CITY OF ALBUQUERQUE

Re: Dripline (Biergarten)
13202nd St NW
Traffic Circulation Layout
Engineer's/Architect's Stamp 10-23-2019 (J14D046)

**TRAFFIC
CIRCULATION
LAYOUT PLAN**

C102

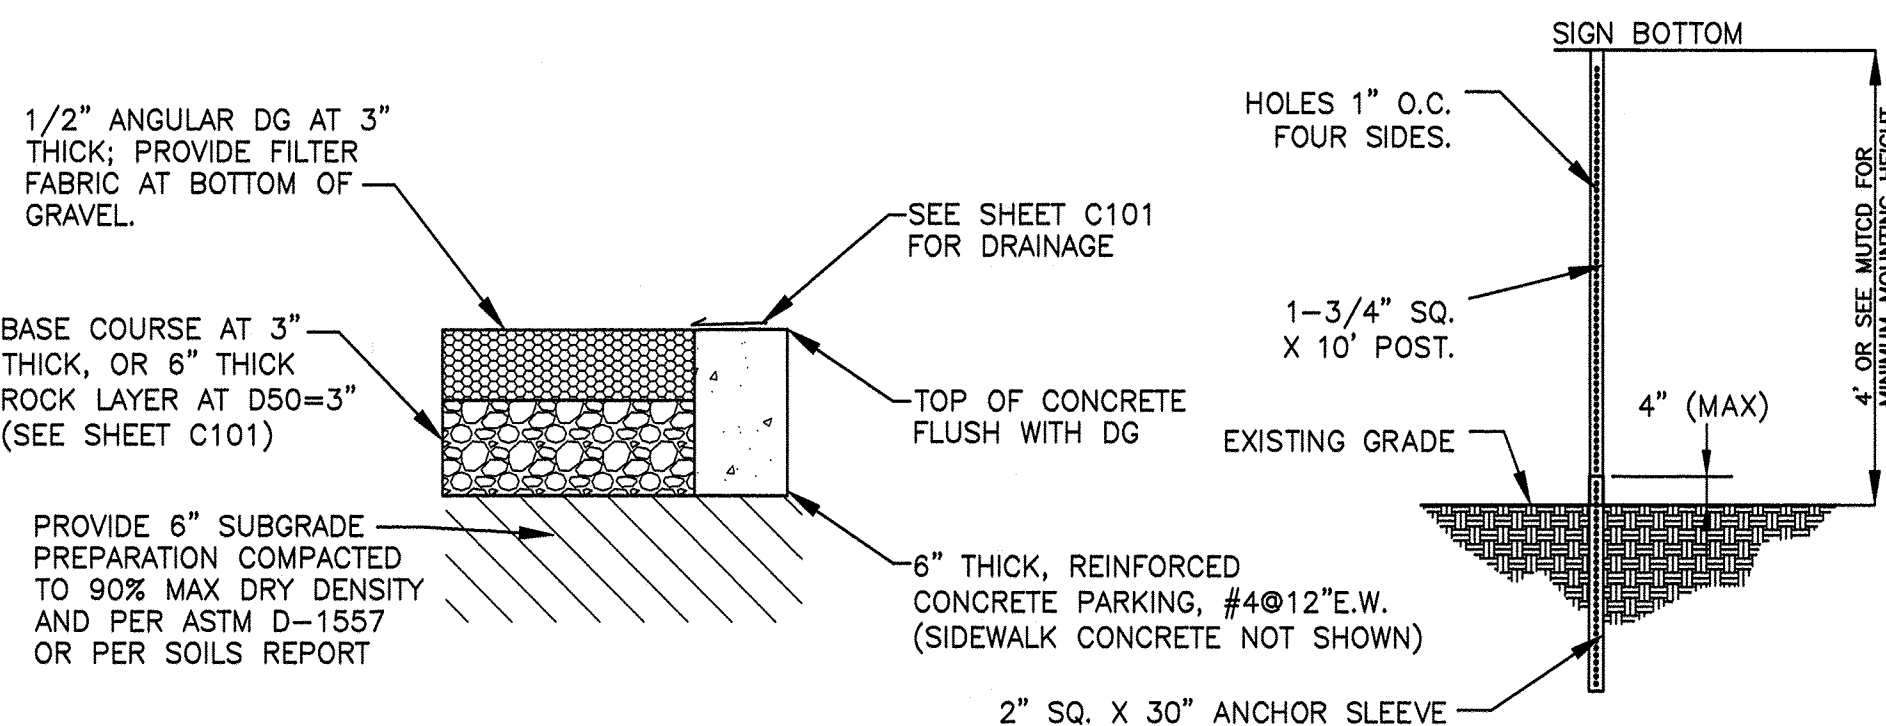
The TCL submittal received 10-30-2019 is approved for Building Permit with **the condition of the approved plat which will be checked at the time of CO.** A copy of the stamped and signed plan will be needed for each of the building permit plans. Please keep the original to be used for certification of the site for final C.O. for Transportation.
